Re: 3 Storer Street (Pratt House)
Chart 61 Block G Lot 4
Zoning Application # 922

Conditional Use Application by Waynflete School: 3 Storer Street

date: November 29, 2007
project: WAYNFLETE ARTS CENTER, PHASE TWO, 2003-0040
re: Mike Nugent questions of November 24, 2007.
to: Mike Nugent City of Portland

Below are questions proposed by Mike Nugent, consulting Plans Examiner, City of Portland in an e-mail on November 24, 2007. **Responses by Scott Simons Architects are noted in Bold**

64.000 inch 68 Degree Carbon Steel,
Yellow with Standard Narrow Handrail

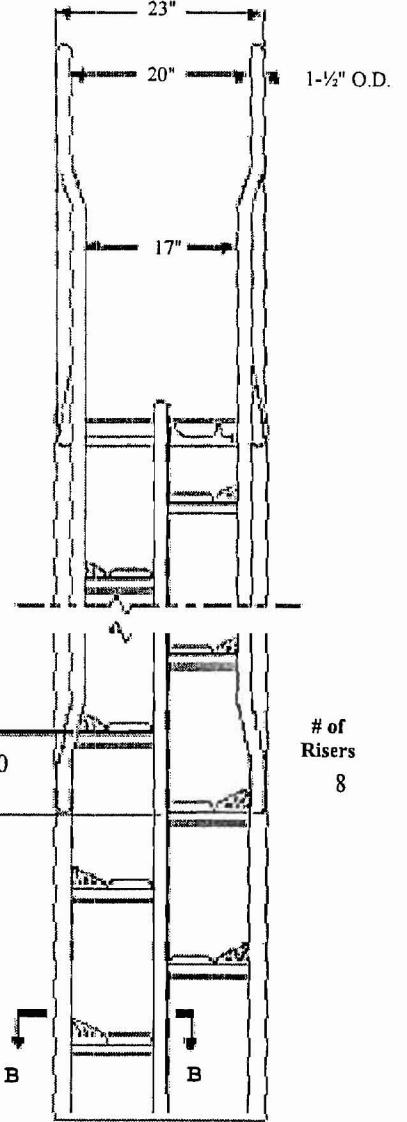
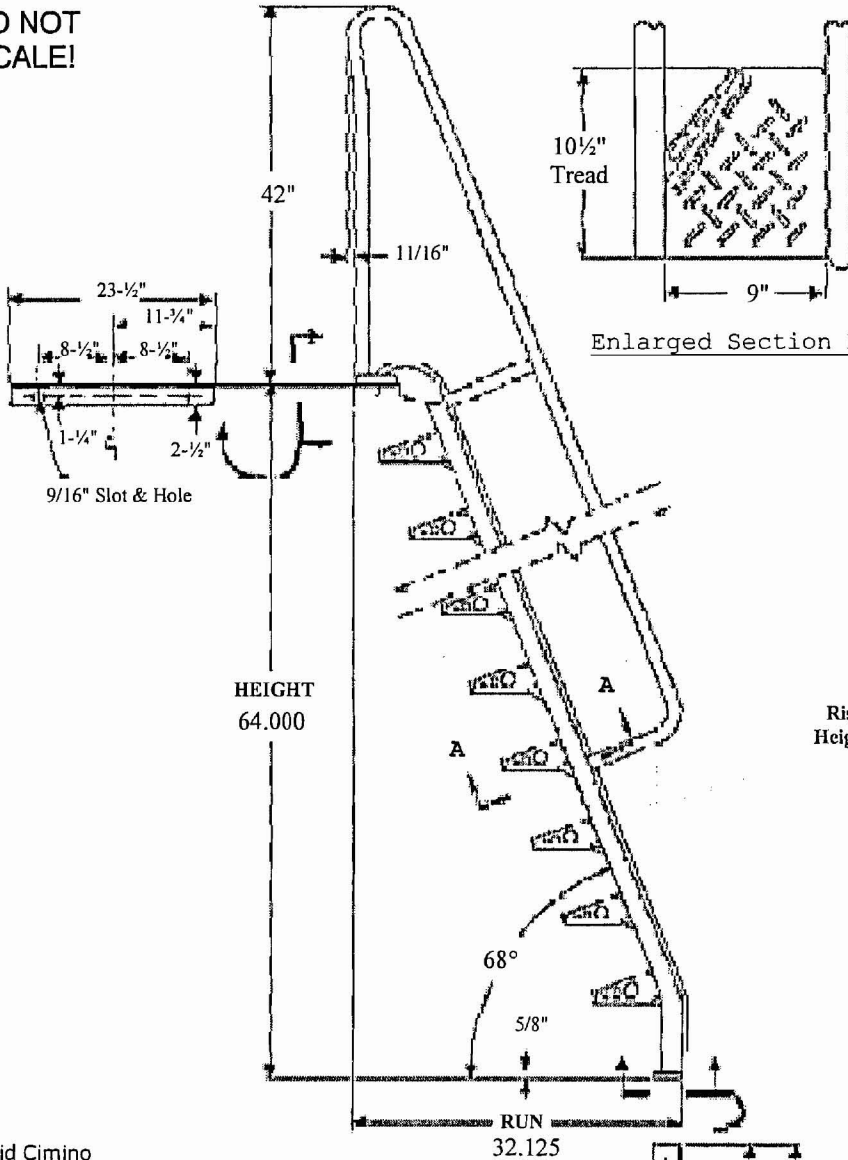
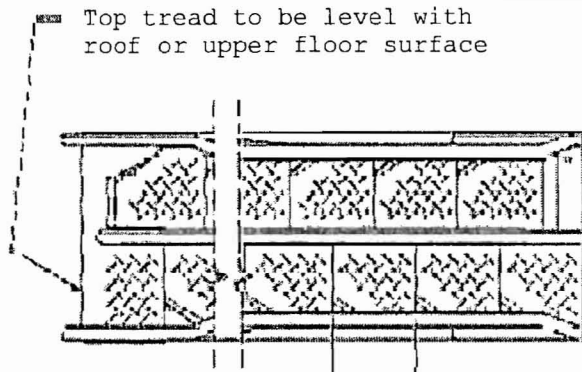
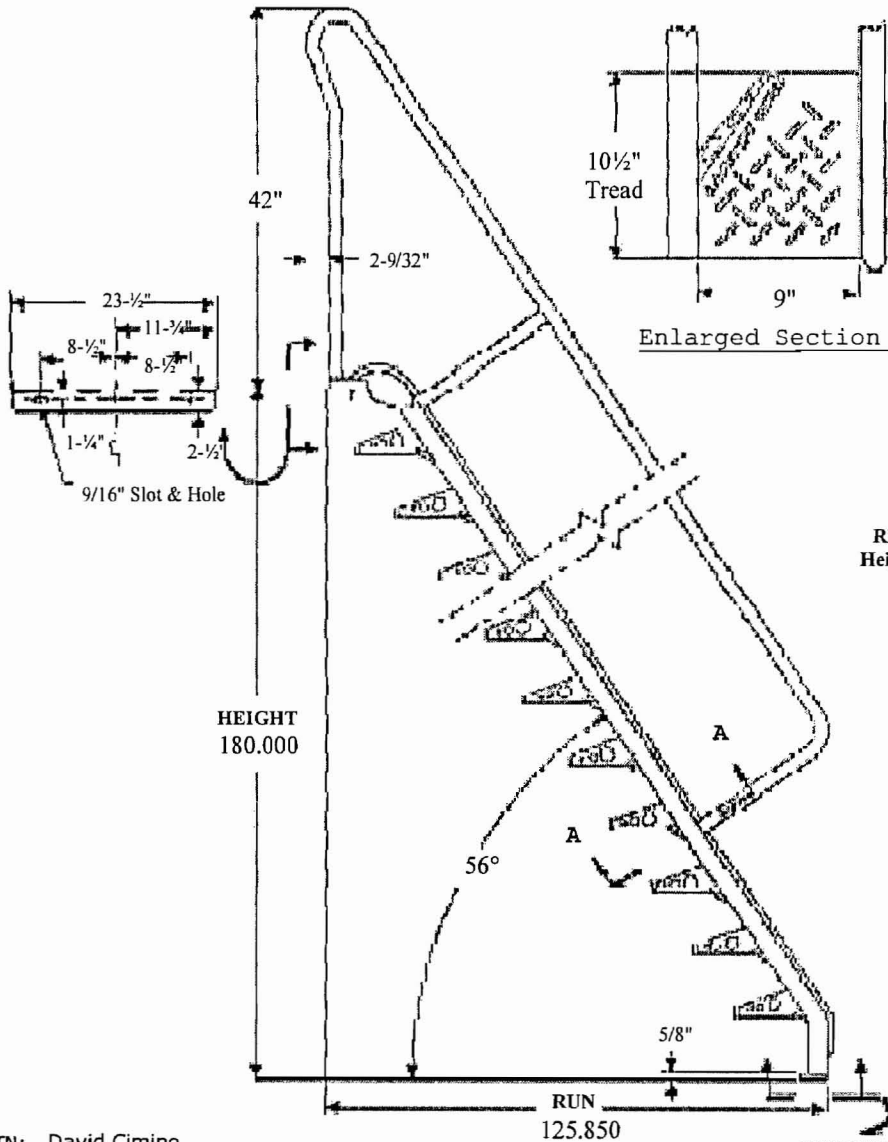
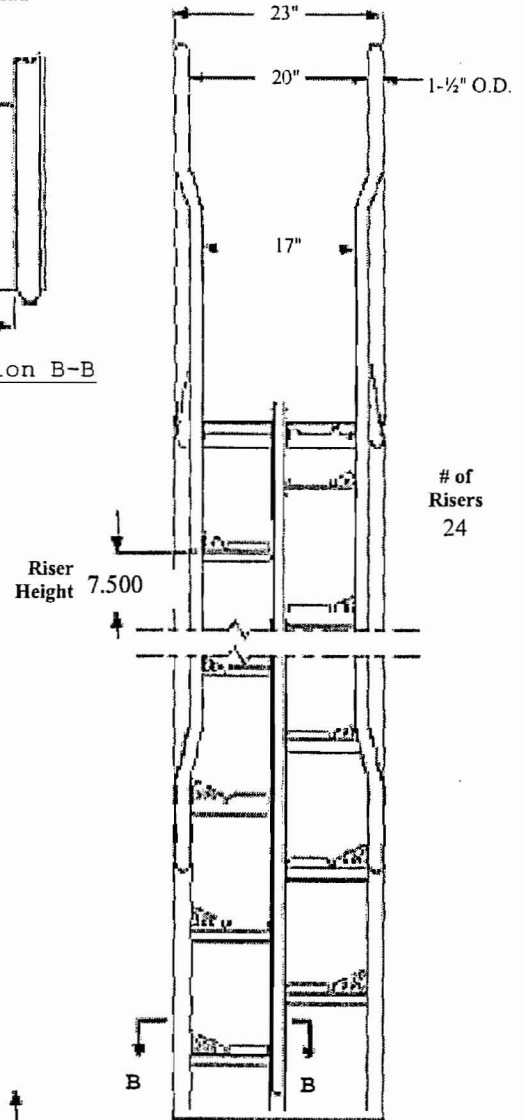
6) Please provide specs for the alternating tread stairs that establishes compliance with all elements of section 1009.10.
